**Subject:** Correspondence Regarding Group III (Email 7), Freedom of Information Act (FOIA) Request DON-NAVY-2017-003161 - Camp Lejeune - P1383 & P1384 Base Entry Point / CLEO Building Projects Contract No. K1310-002-S / Project Number K1310 SLO Case No. 16-970

Cc: (b)(6) (Group III Mgt.); (b)(6) (PM, Group III Management); (b)(6) (Group III Mgt Superintendent); (b)(6); (b)(6) NAVFAC MIDLANT, IPTMC  
Subject: RE: PRELIMINARY CLEO TAB REPORT

SCALE: AS NOTED  
PROJECT NO: P1383  
CONSTR. CONTR. NO:  
NAVFAC DRAWING NO: 12593052  
SHEET 54.1 OF 1049  
A-601

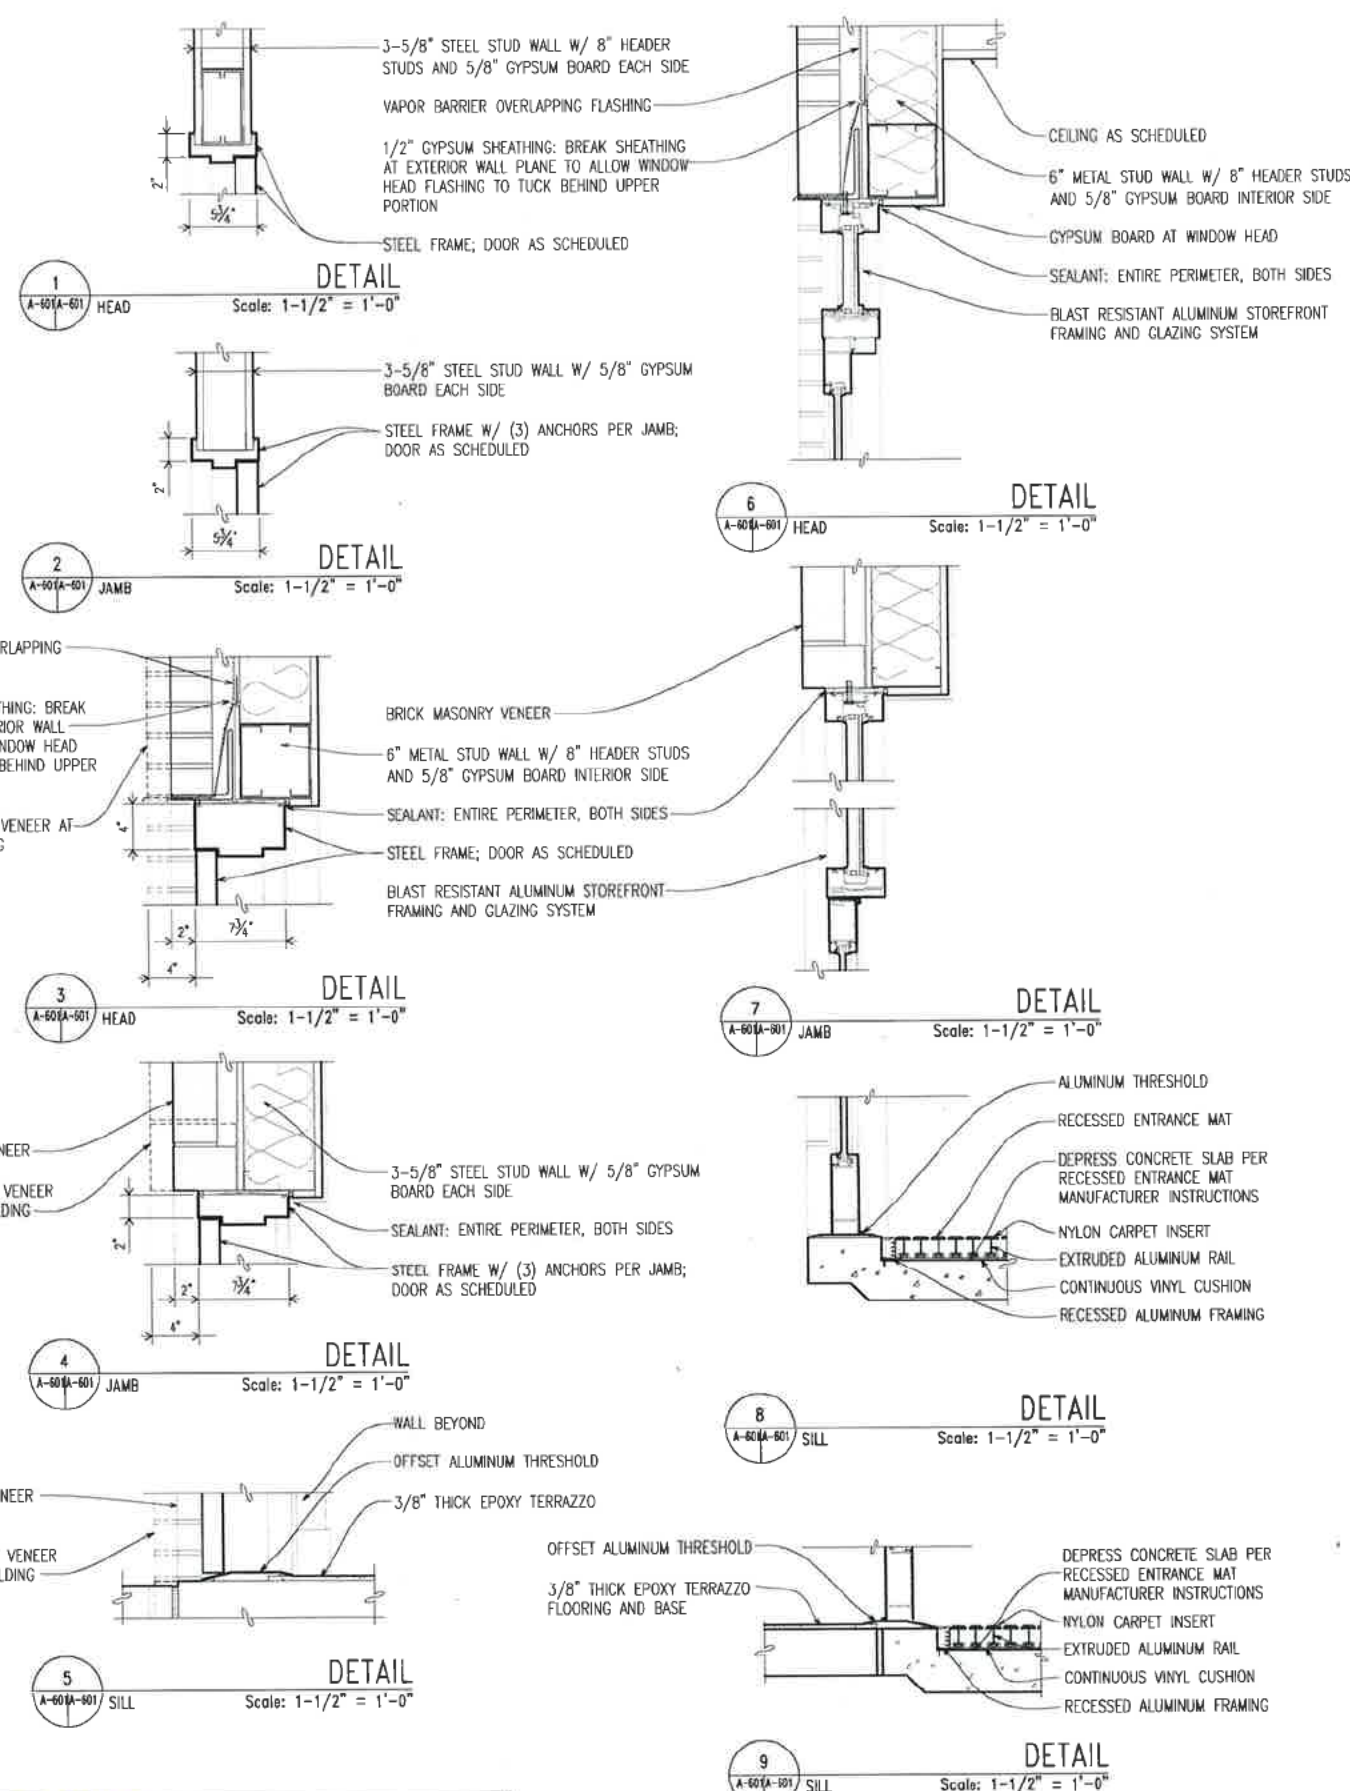
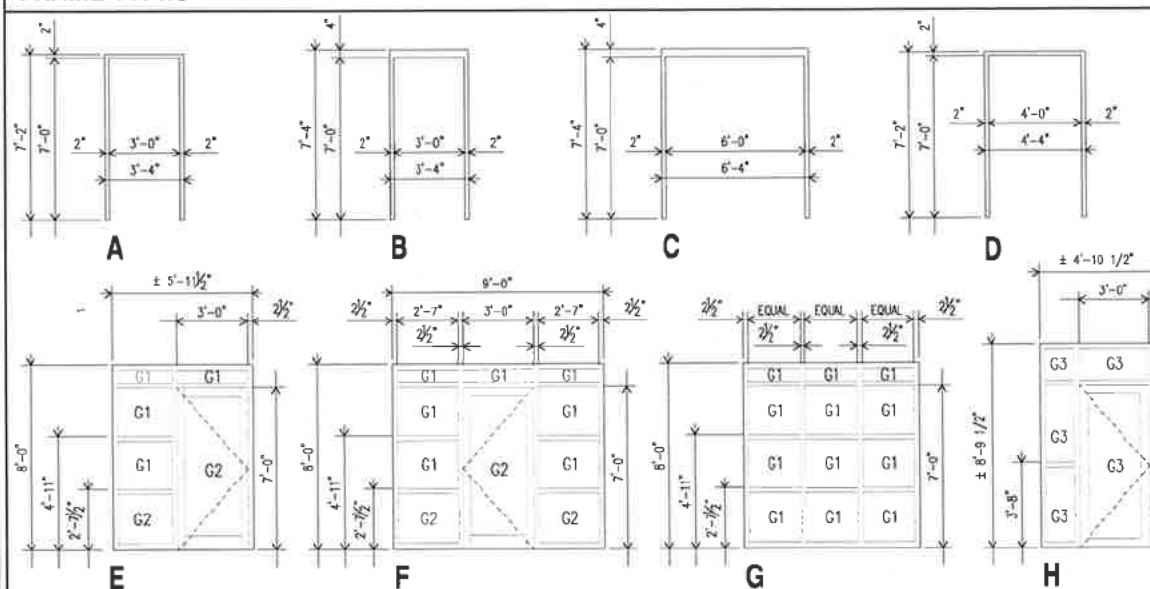
From: (b)(6) [mailto:(b)(6)] Door 122A is not noted as being a bullet resistant door. All of the other doors are bullet resistant, at the gatehouse (please see the door schedule on sheet A-601). This seems curious to us b/c this door leads into the NMCI room – probably the most critical room in the building! With that stated, the frame the supplier sent is bullet resistant. It has already been installed. The door is not bullet resistant and has not been installed. We have 2 options here:
